1955 Corvette: Service Bulletin: Hard Shifting

CHEVROLET—CENTRAL OFFICE DIVISION OF GENERAL MOTORS CORPORATION DETROIT 2, MICHIGAN	
TECHNICAL SERVICE BULLETIN Service and Mechanical Department	
SUBJECT: HARD SHIFTING - 1955 MODEL PASSENGER CAR 3-SPEED TRANSMISSION	BULLETIN No. DR #236 SECTION VII
TO: ALL CHEVROLET DEALERS	January 9, 1956
<p>In cases where hard shifting on 1955 Passenger Models with 3-Speed Transmission is experienced in high frequency shifting operations due to malfunction and/or wear of gearshift controls and butting of transmission gears, the condition may be reduced by installation of a Transmission Control Conversion Kit and three new type transmission gears.</p> <p>The new transmission gears which have more tooth chamfer entered production about July 5, 1955.</p> <p>The revised transmission controls entered production beginning with 1956 Model and the Control Conversion Kit has modified parts for use on 1955 Models.</p>

FIGURE I

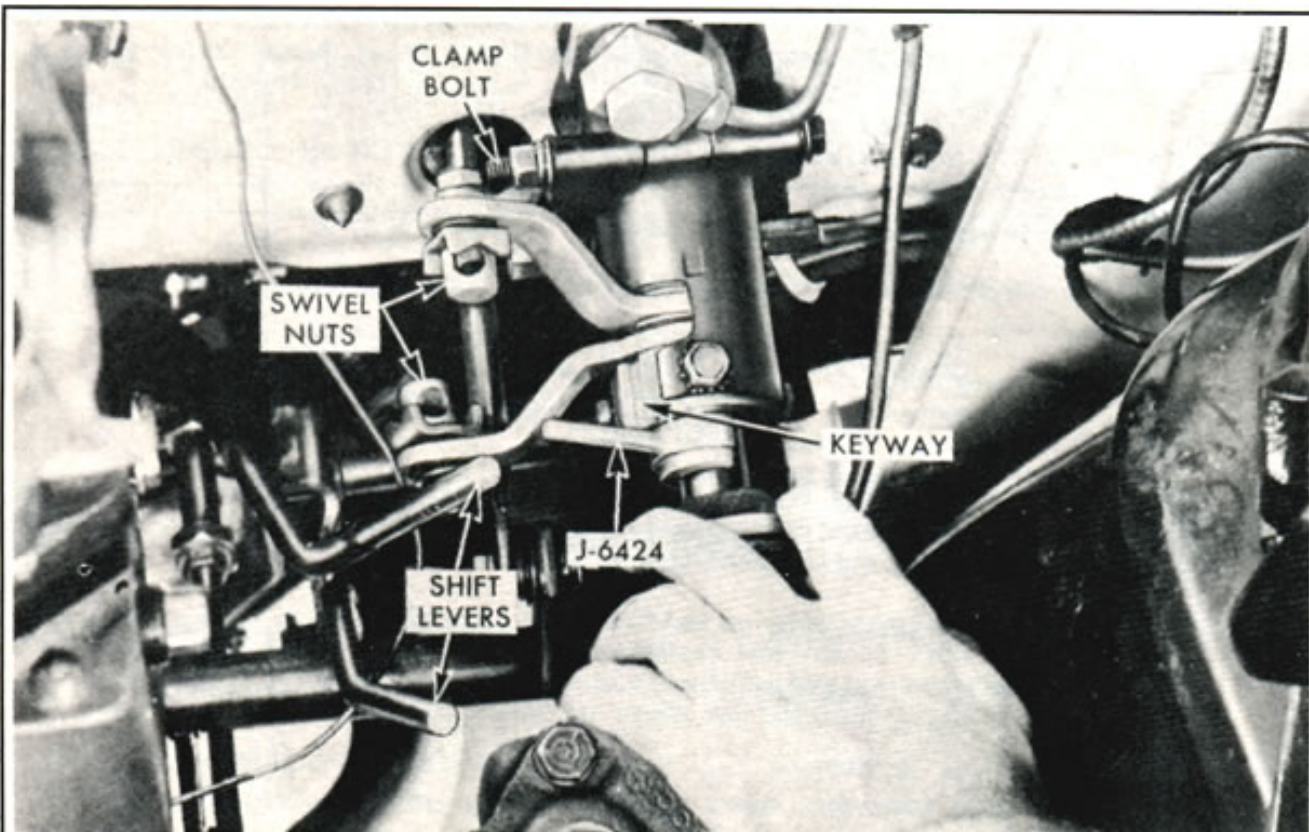
13. Insert gearshift rod ends in swivels - transmission must be in neutral detent in both ranges. Do not tighten.
14. Install alignment gauge J-6424 inserting side stamped "STD" between steering mainshaft and shifter tube in key area. This sets the required 1/16 eccentricity in proper relation to the key on shifter tube. See figure 1.

FIGURE 2

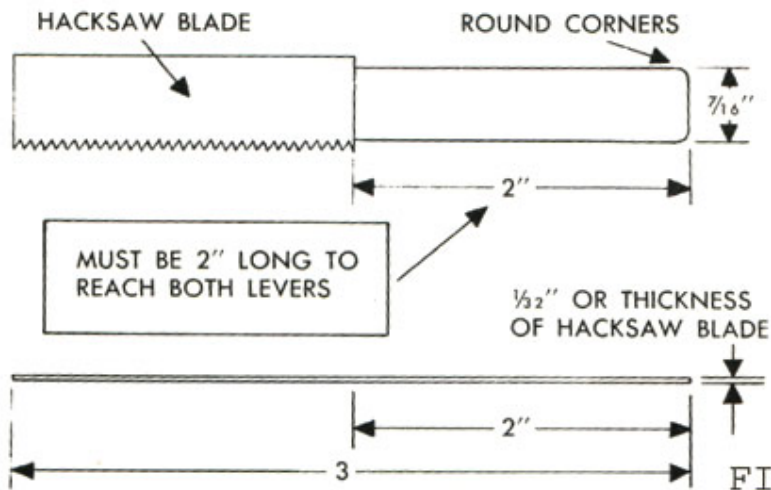
- c. Remove alignment gauge.
16. Make and insert special blade gauge, see figure 2, thru adjusting ring slot, lower levers and gate washer. Tighten swivels on gearshift rods while holding downward lightly on lower levers. Transmission must be in neutral detent at this time.

FIGURE 3

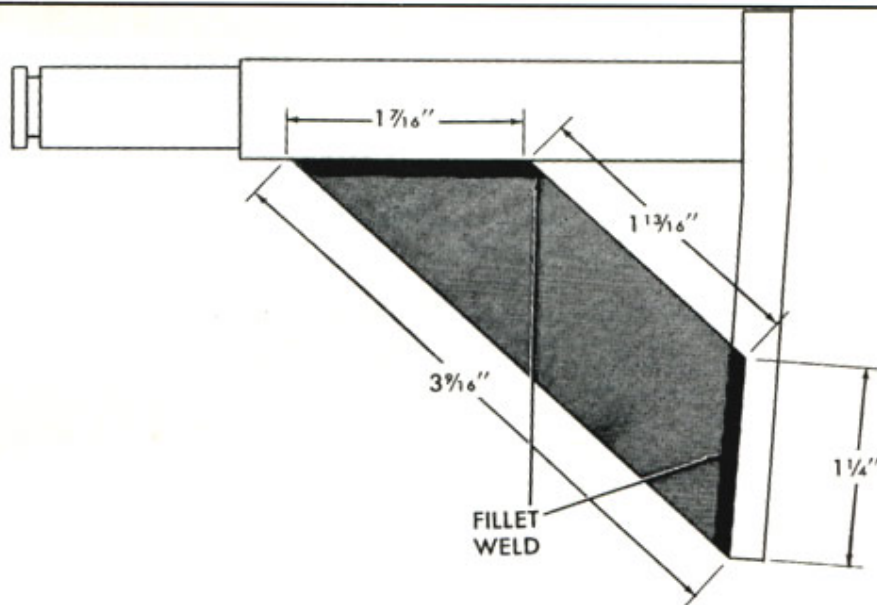
Further improvement of shifting can be made by reinforcement of transmission control rod idler lever support located on left frame rail under toe pan to reduce its deflection. See figure 3.
